PRODUCT / PROCESS CHANGE NOTIFICATION

1.1 Company		STMicroelectronics International N.V
1.2 PCN No.		ADG/18/10722
1.3 Title of PCN		Conversion from 4" to 6" of 1200V SiC Schottky diodes production line
1.4 Product Category		SiC diodes in 1200V
1.5 Issue date		2018-02-12

Conversion from 4" to 6" of 1200V SiC Schottky diodes production line

Notification number:	ADG-DIS/18/10722	Issue Date	08/02/2018		
Issued by	Aline AUGIS				
Product series affected by the change:		1200V Power Schottky SiC diodes			
Type of change:		Front end realization			
Description of the change					
Wafer diameter conversion from 4" (100mm) to 6" (150mm) for 1200V Power Schottky SiC diodes					
Reason for change					
Capacity extension with 6" conversion and 4" production line phase out					
Former versus changed product:		<p>The changed products do not present modified electrical, dimensional or thermal parameters, leaving unchanged the current information published in the product datasheet</p> <p>The Moisture Sensitivity Level of the part (according to the IPC/JEDEC JSTD-020D standard) remains unchanged.</p> <p>The footprint recommended by ST remains the same.</p> <p>There is no change in the packing modes

Marking and traceability

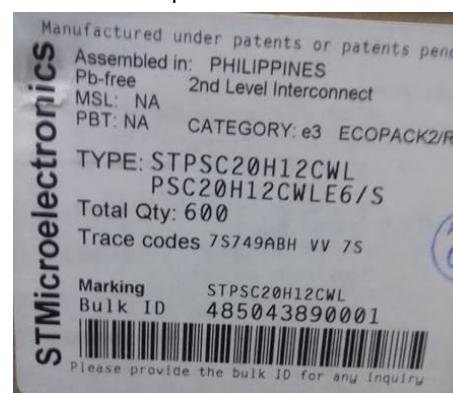
The traceability is ensured by the creation of new internal codifications (Finish good) and by the QA number. Examples of FG codes and labels here below:

Sales type	4" Finished Good code	6" Finished good code
STPSC20H12CWL	PSC20H12CWL/S	PSC20H12CWLE6/S
STPSC10H12D	PSC10H12D/7	PSC10H12DE6/7
